Addendum 02

PROJECT: Zane Grey Intermediate School MVHC Clinic Renovation
968 Pine Street
Zanesville, Ohio 43701

PROJECT #: 25006.02

SHEET TITLE:
**DOOR SCHEDULE &
DOOR DETAILS**

14 SILL DETAIL - INTERIOR
1 1/2" = 1'-0"

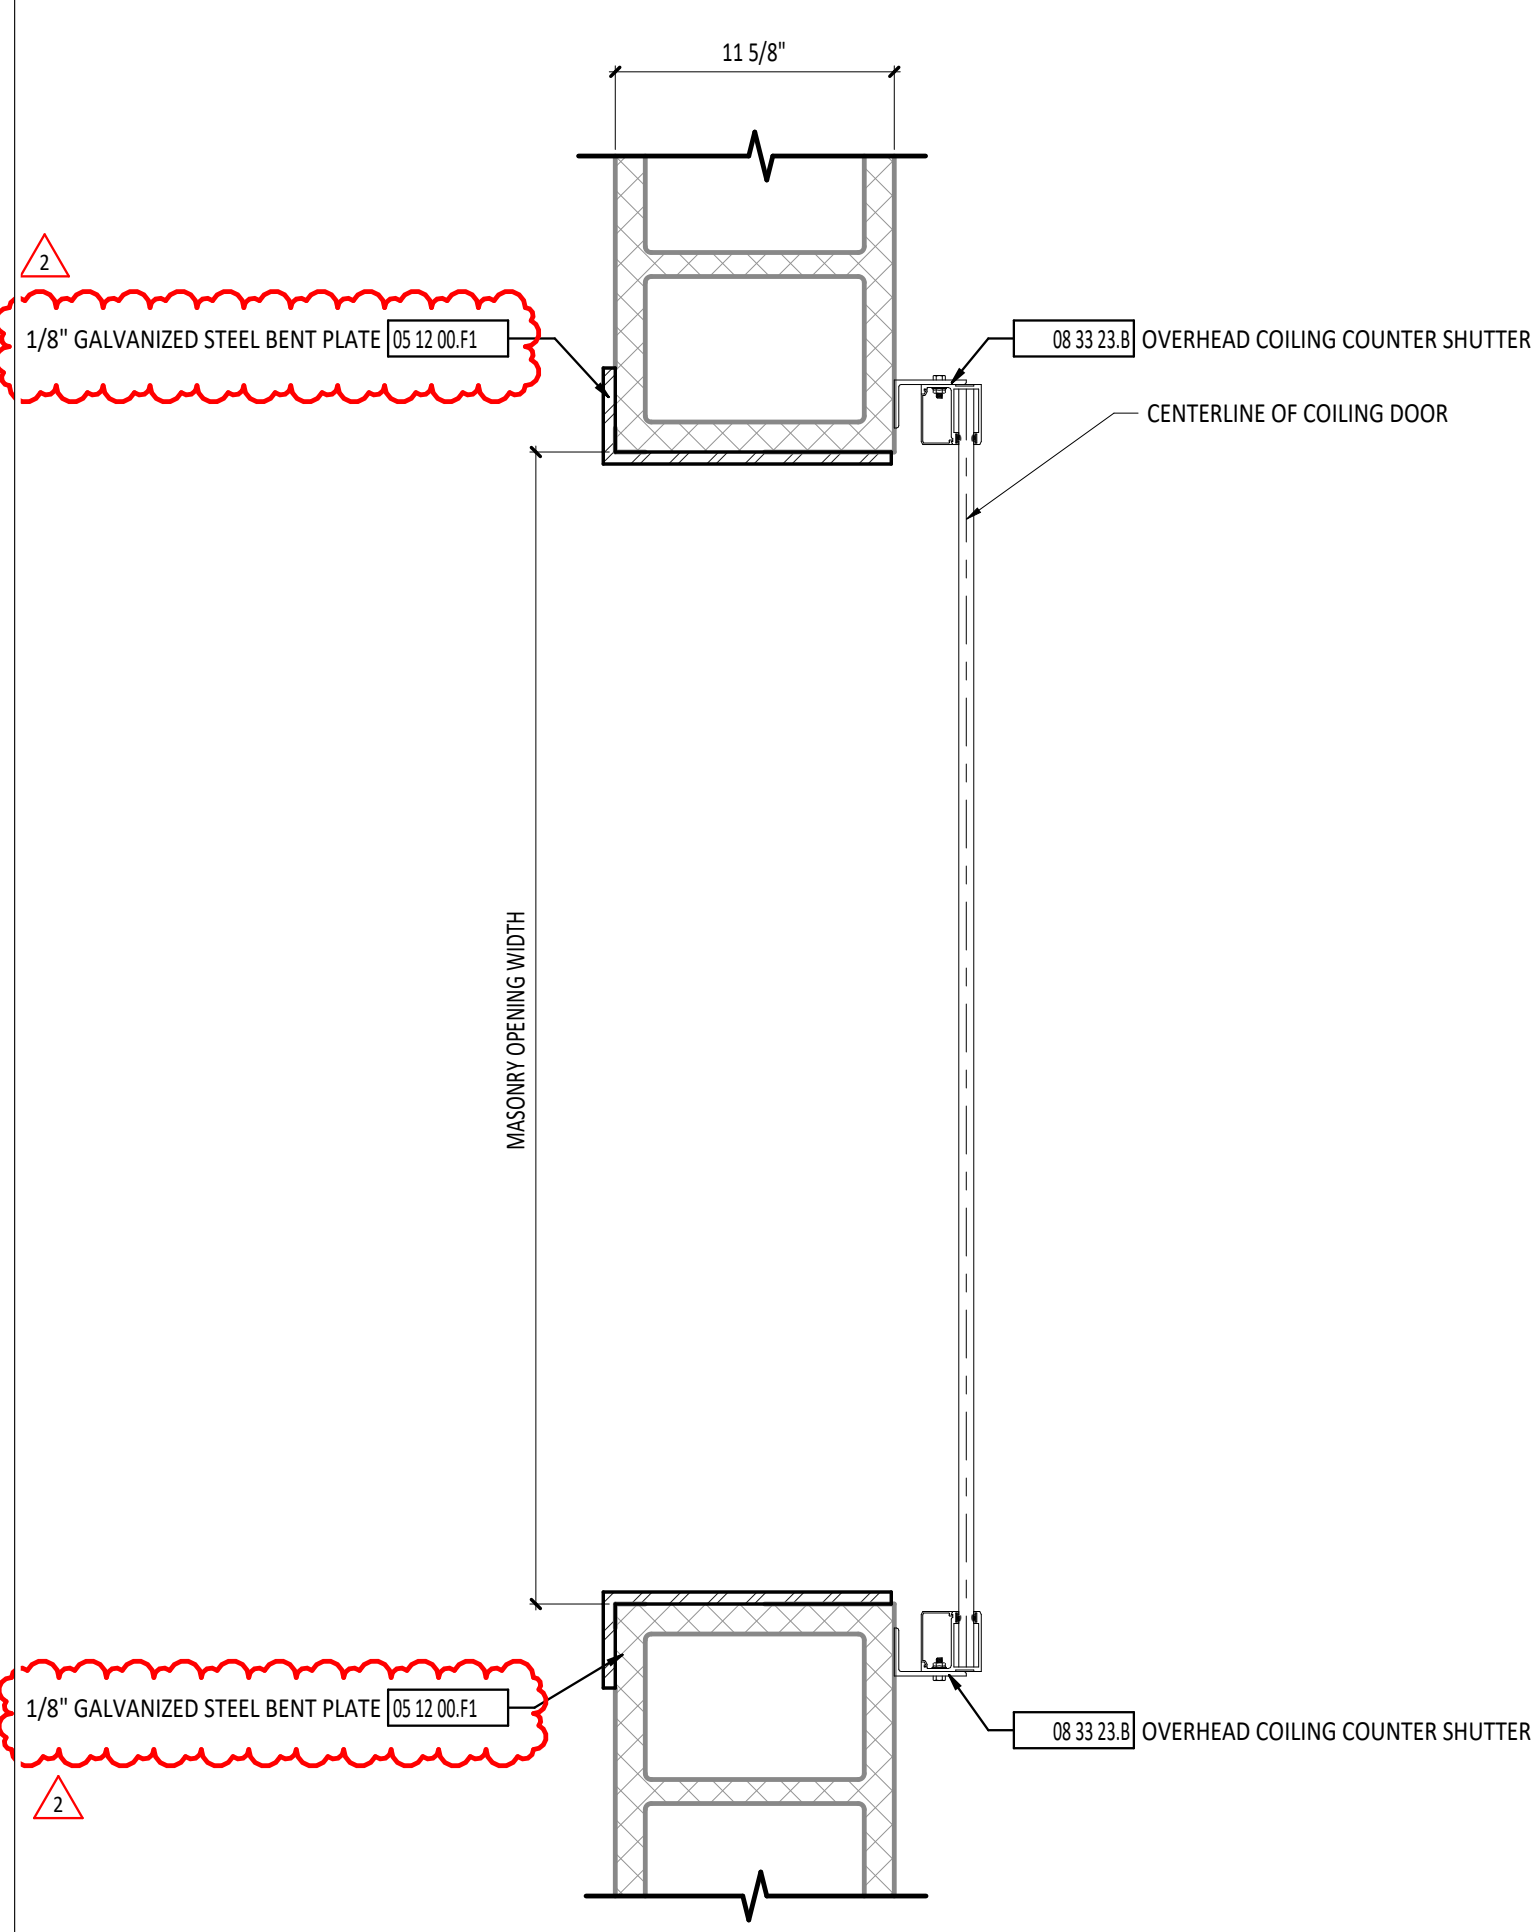
1. Drawing Sheet A6.1 – Door Schedule & Door Details:
 - a. Indicate thickness of bent plate for details 14/A6.1 and 15/A6.1.
